FIGURE 18

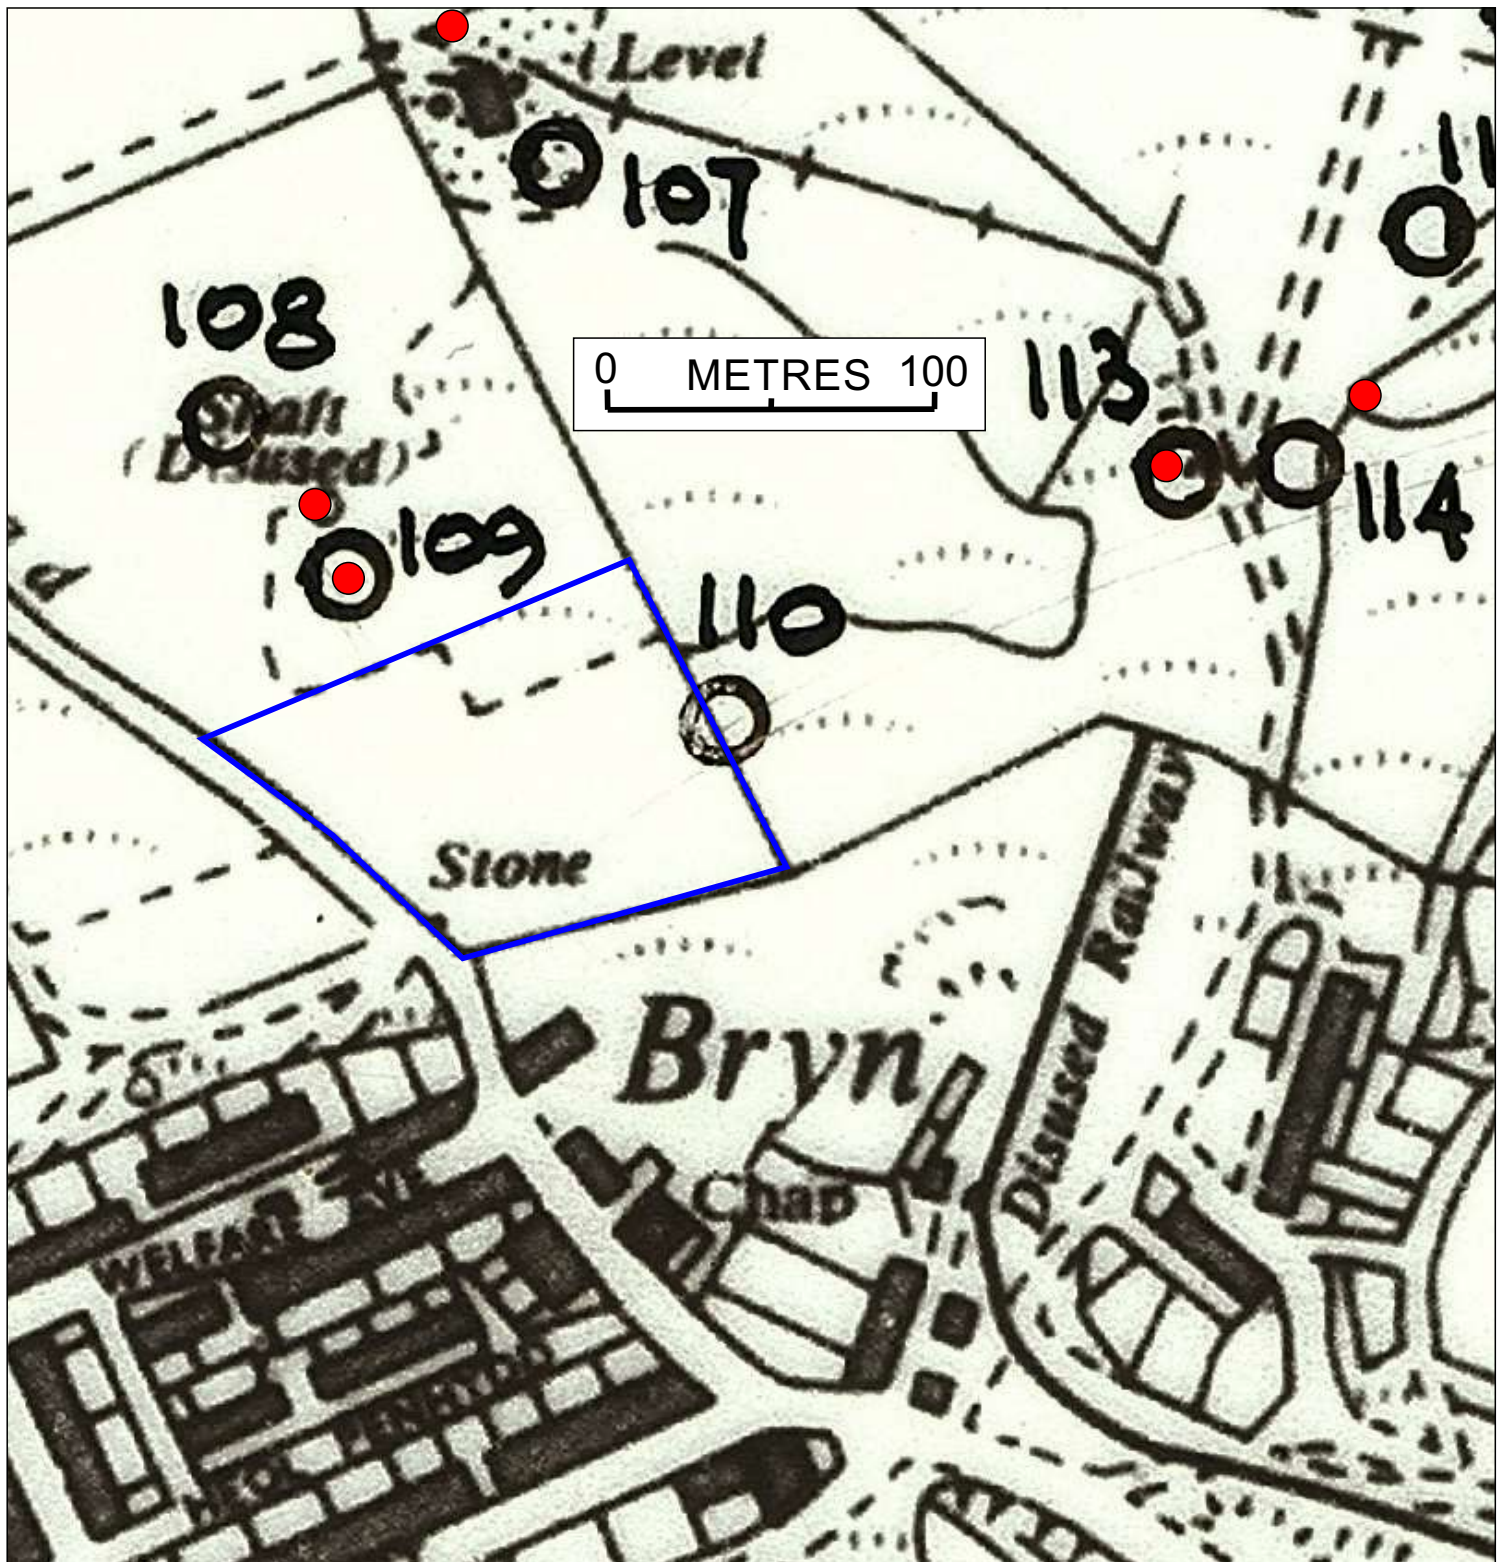
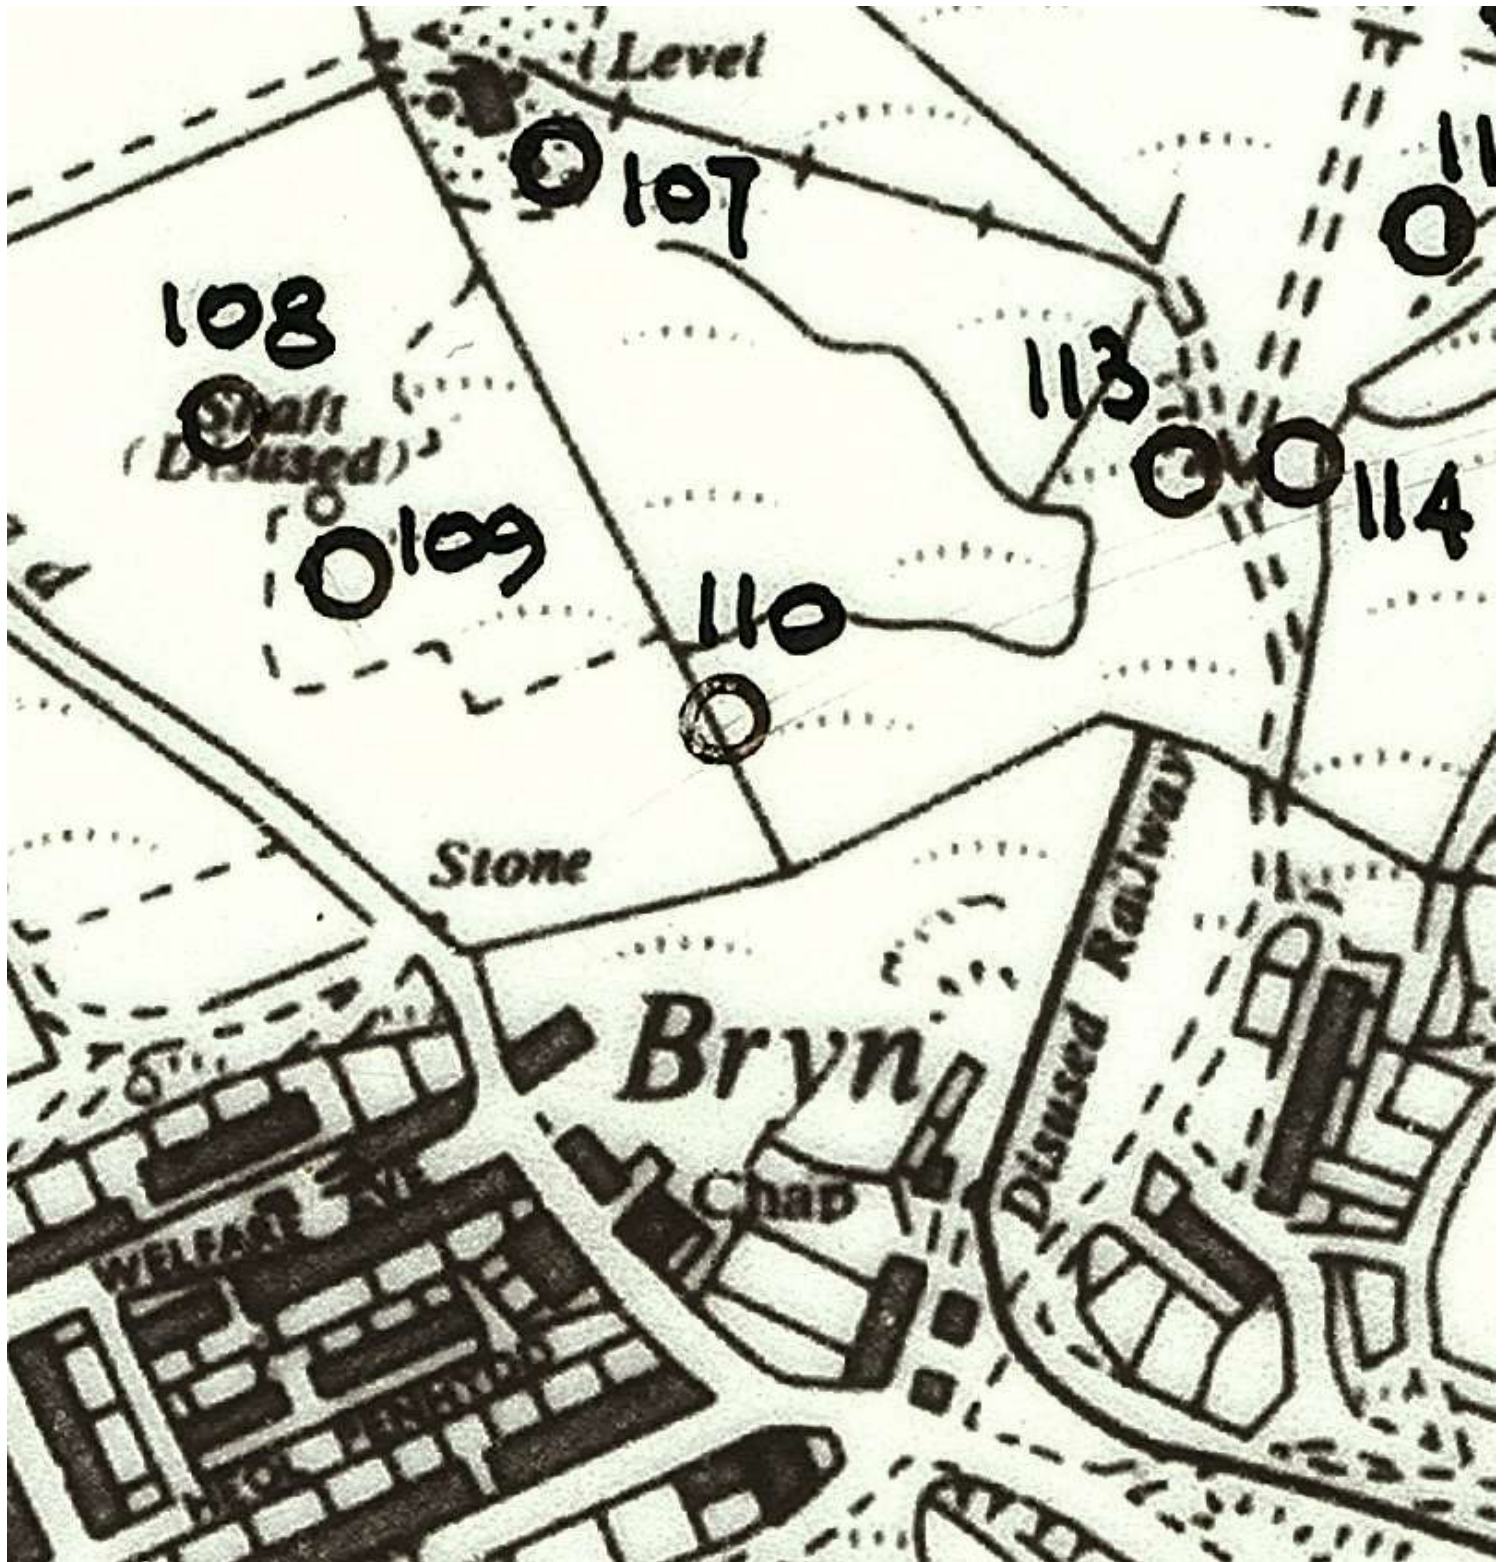
It has been freely admitted by the C.A. that there is only a single source of evidence for this. This source is the West Wales Shaft Register (the name is a slight misnomer as it includes all mine entrances, not just shafts). This is a crude hand-drawn diagram of N.C.B./British Coal liabilities sketched onto National Grid map SS89SW, with the original author unknown. Darren Moody has been kind enough to send a copy of the original. An extract is reproduced as Figure 18 overleaf. The inaccuracies are immediately apparent. The map is at 1:10,000 scale which is rather small, and not ideal. The site has been outlined in blue. The red circles mark the positions of the mine entrances, as actually recorded on the base O.S. map. Even though the hand drawn circles are greater than 20m across when scaled, they still manage to sometimes completely miss the target. To insist that 110 on the shaft register (281192-076) could not represent the staple pit because it is "23m away" does not stand up to scrutiny in these circumstances. Some of the other mine entrance positions on this small extract have a larger margin of error.

SHAFT 108 IS 40m OFF POSITION, LEVEL 107 IS AT LEAST 50M OFF POSITION, LEVEL 109 IS ON POSITION. LEVEL 113 IS ON POSITION, LEVEL 114 IS 20M OFF POSITION AND TWO OTHER LEVELS IN THE IMMEDIATE AREA OF 113/114 ARE NOT MARKED. THE MAP IS A CRUDE, HAND DRAWN SKETCH OF THE APPROXIMATE LOCATION OF NCB LIABILITIES. 110 COULD CERTAINLY BE INCLUDED BY ERROR.

FIGURE 19

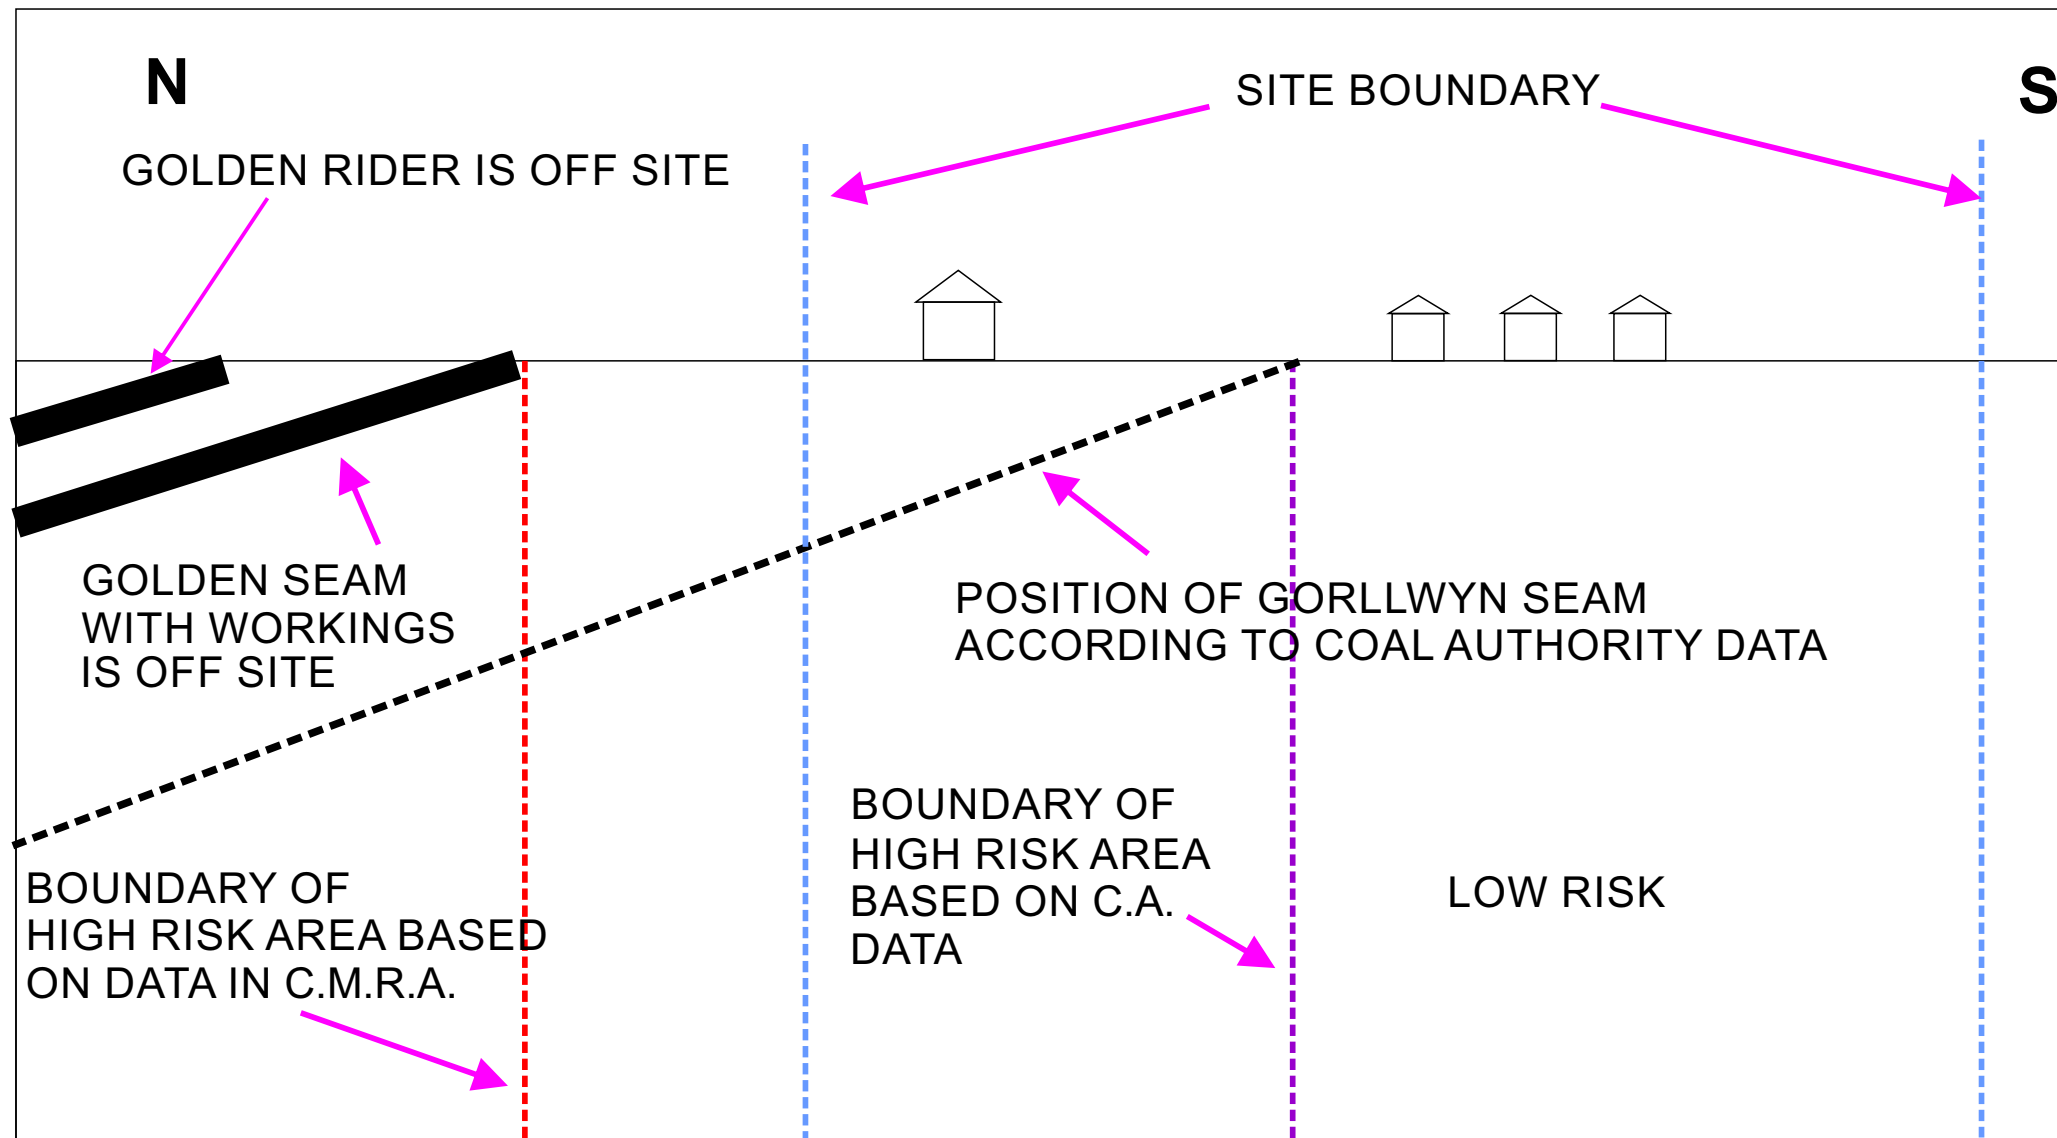
A NORTH SOUTH SECTION OF THE SITE SHOWING THE REASON FOR THE COAL AUTHORITY DEVELOPMENT HIGH RISK RATING AND AN ALTERNATIVE BOUNDARY SUPPORTED BY THE DATA PRESENTED IN THE C.M.R.A.
